World Forum for Harmonization of Vehicle Regulations

Working Party on Brakes and Running Gear

Proposal for a Draft 01 Series of Amendments to the Regulation on advanced emergency braking system

Submitted by the Informal group on [**Automatic Advanced**] Emergency Braking and Lane Departure Warning Systems (AEBS/LDWS) *

Arrangements of approval marks

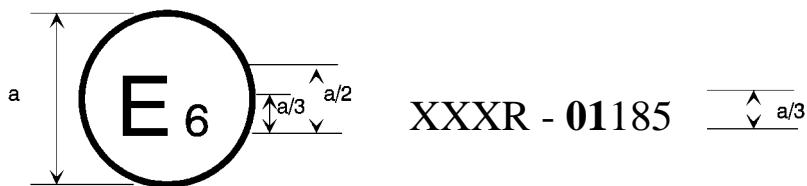
Annex 2, amend to read:

The above approval mark affixed to a vehicle shows that the vehicle type concerned has been approved in Belgium (E6) with regard to the AEBS pursuant to Regulation No. XXX. The first two digits of the approval number indicate that the approval was granted in accordance with the requirements of **the 01 Series of Amendments to the Regulation No. XXX in its original form.**
